SUBJECT: ISSUANCE OF AMENDMENT (TAC NO. 69568)

The Commission has issued the enclosed Amendment No.137 to Facility Operating License No. DPR-65 for Millstone Nuclear Power Station, Unit No. 2, in response to your application dated September 20, 1988.

MILLSTONE NUCLEAR POWER STATION, UNIT NO. 2

Amendment No. 137  
License No. DPR-65

Figure 3.2.1 Allowable Peak Linear Heat Rate vs. Burnup

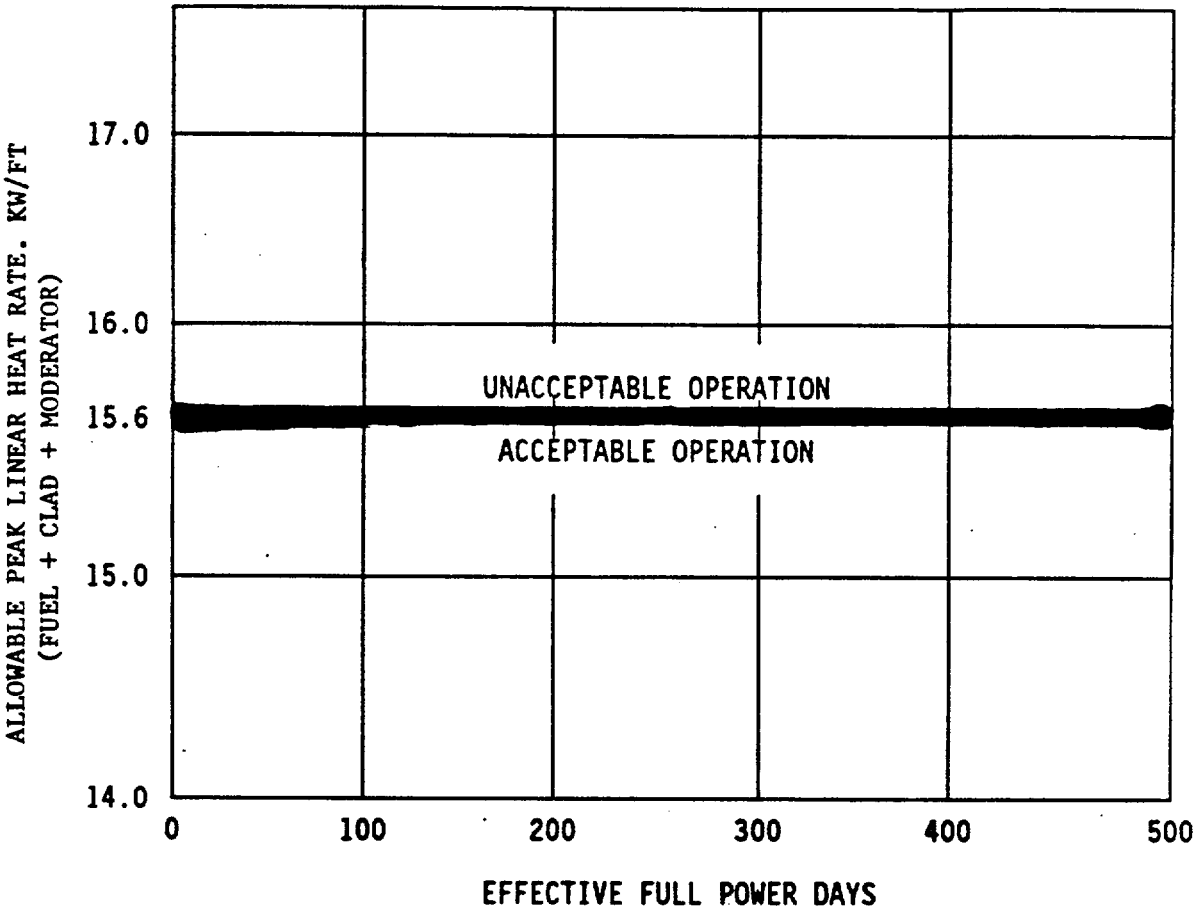
The change modifies the Technical Specifications (TS) as follows: (1) the maximum linear heat rate shown in TS Figure 3.2.1 is reduced from 15.6 to 14.0 kw/ft, and (2) a factor of 1.115 is applied to the total planar radial peaking factor for reactor operation during Cycle 9 beyond a core average burnup of 10,000 MWD/MTU.

Westinghouse has evaluated the Millstone Unit 2 LOCA analysis and found that Cycle 9 coastdown operation is acceptable provided that: (1) The maximum linear heat rate is reduced from 15.6 Kw/ft to 14.0 Kw/ft. (2) An additional multiplier of 1.115 (equal to 15.6/14.0, the ratio of the maximum linear heat rates) is included in the total planar radial peaking factor.

The licensee has proposed to reduce the allowable maximum linear heat rate (LHR) and total planar radial peaking factor ( $F_{xy}$ , T) by 11.5% for extended operation, as reflected in proposed TS Figure 3.2.1, "Allowable Peak Linear Rate vs. Burnup." The licensee has also proposed the use of a multiplying factor of 1.115 on  $F_{xy}$ , T in TS 3/4.2.2, "Total Planar Radial Peaking Factor -  $F_{xy}$ , T, for operation beyond 10,000 MWD/MTU. These reductions allow the average LHR to remain unchanged while increasing restrictions on boundary conditions during extended operation. Using known sensitivities of the LHR that have been used in previous Millstone 2 operating cycles, the proposed maximum allowable values for LHR and  $F_{xy}$ , T would compensate for the effect of extended operation on the bounding LOCA<sup>xy</sup> transients. These sensitivities were determined using NRC staff-approved, ECCS evaluation models. Therefore, the results of the evaluation ensure a PCT, local cladding oxidation rate, and whole-core hydrogen generation level that remain within the values for Cycle 9, which satisfy the requirement of 10 CFR 50.46. Accordingly, the proposed changes to the TS are acceptable.

\* A limit of 14.0 KW/FT is required for Cycle 9 only whenever the cycle average burnup is  $\geq 10,000$  MWD/MTU

A reduced linear heat rate limit of 14.0 kW/ft for Cycle 9 operation beyond a cycle average burn-up of 10,000 MWD/MTU ensures that the 2200°F peak fuel cladding temperature limit will not be exceeded in the event of a LOCA. The value of 10,000 MWD/MTU is the predicted end-of-cycle for Cycle 9. Operation beyond the predicted end-of-cycle may require reductions in the reactor coolant temperatures which can increase the calculated peak clad temperatures. The reduction in the linear heat rate limit will more than compensate for the effect of the reduction in the reactor coolant temperatures on the LOCA analysis.
